ORDINANCE NO. 24-3-5

An ordinance approving and authorizing the execution of Change Order No. One (1) for the Barber Road Bank Stabilization, (Project No. P210702), to increase the contract amount by \$64,659.69 and increase the contract time by 7 calendar days.

CHANGE ORDER

Project: Barber Road Bank Stabilization

SECTION "A-A"

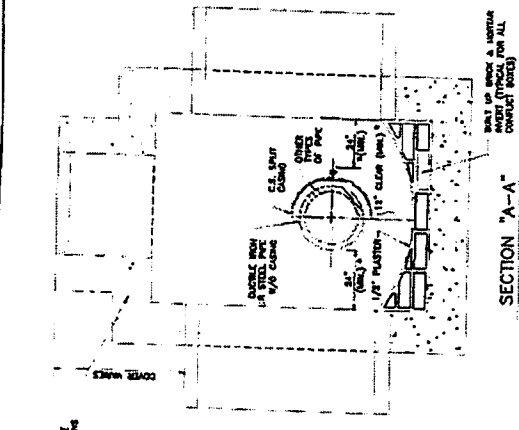
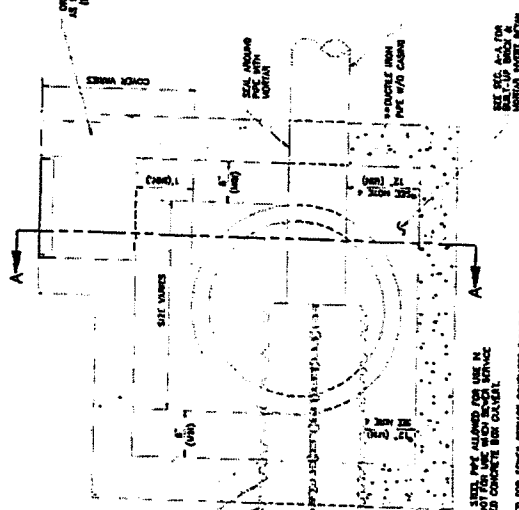
Description: Enter description of changes for Contractor.
In reference to RFI #5 & COR #4, Command is directed to replace the existing D.I. with a conflict box(Brick or CIP) using bituminous coated corrugated steel split casing around the existing sewer house connection and tie in existing 15" RCP drainage to new conflict box. Split casing to be 8" min (up-sized from existing 6" sewer line). In addition, replace the existing 24" PVC drain line with 24" STORM DRAIN PIPE (CPPPDW) in lieu of the proposed 30" Pipe to avoid existing SFM and gas line utility conflicts.

1. SPLIT CASING SHALL BE PROVIDED (100% / 100%) IN ACCORDANCE WITH AASHTO SPECIFICATIONS 2.11E, 2.11F AND 2.11G, 12.02C.
2. IF BETWEEN ELEMENTS OF THE CONFLICT IS ABOVE THE LOWER JOB OF THE ROAD, THE WEIGHT OF THE ROAD SHALL BE MAINTAINED TO THE MAXIMUM EXTENT POSSIBLE.

3. ALL UTILITY LINES IN CONTACT SHALL BE BUSTLE FROM PPE. OTHER PPE MATERIAL SHALL BE REPAIRED IN SPLIT CASING.
4. CLEARANCES SHOWN ARE NOT FOR INCREASED CROSS MEMBERS, BUT ARE MINIMUM CLEARANCES REQUIRED FOR PROPER INSPECTION AND MAINTENANCE OF THE UTILITY CASING. IN THE EVENT OF THE CONFLICT WITH THE CURB OR SIDEWALK, THE CASING SHALL BE REPAIRED TO THE ORIGINAL FINISH. ALL CLEARANCES AND CONTACT POINTS SHALL BE RECHECKED AND RECORDED. ALL CLEARANCES AND CONTACT POINTS SHALL BE RECHECKED AND RECORDED. ALL CLEARANCES AND CONTACT POINTS SHALL BE RECHECKED AND RECORDED.
